UNITED STATES PATENT AND TRADEMARK OFFICE

APPLICATION NO.	FILING DATE	FIRST NAMED INVENTOR	ATTORNEY DOCKET NO.	CONFIRMATION NO.
10/038,749	01/02/2002	Gregory A. Lyon	33778	2952
116	7590	03/26/2004	EXAMINER	
PEARNE & GORDON LLP 1801 EAST 9TH STREET SUITE 1200 CLEVELAND, OH 44114-3108			LEE, HWA S	
			ART UNIT	PAPER NUMBER
			2877

Office Action Summary	Application No.	Applicant(s)	
	10/038,749	LYON, GREGORY A.	
	Examiner	Art Unit	
	Andrew H. Lee	2877

DETAILED ACTION

FIG.4

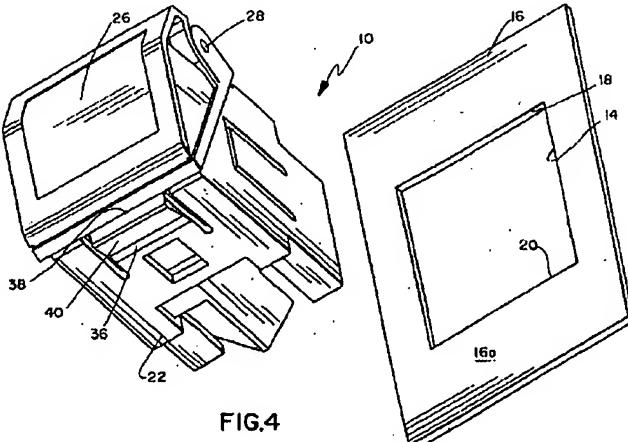
Farnsworth et al (Farnsworth hereinafter) show a connector panel mount system comprising:

a connector receiving housing (12) having a plurality of surfaces for mounting to a receiving member (16) having first and second faces, the connector receiving housing having a cavity therein and one or more passages adjacent the cavity for receiving the fiber optic cable connector;

a protrusion (38 and/or 34)

on the left and rights sides of the connector receiving housing for slidably engaging the first face of the receiving member; and

a lip (34) on the connector receiving housing for engaging the second face of the receiving member;

whereby the housing is mounted to the receiving member by the interaction of the lip and the protrusion.

With regards to claim 2, the protrusion is wedged shaped.

With regards to claim 4, the protrusion and the lip define opposed surfaces.

With regards to claim 9, the passage for receiving a connector is at an angle to an opening of the cavity.

With regards to claim 10, the protrusion defines an edge and permits the receptacle housing to slide through an opening in a receiving member; and whereby the housing is secured into the opening in the receiving member by the interaction of the lip and the edge on the protrusion.
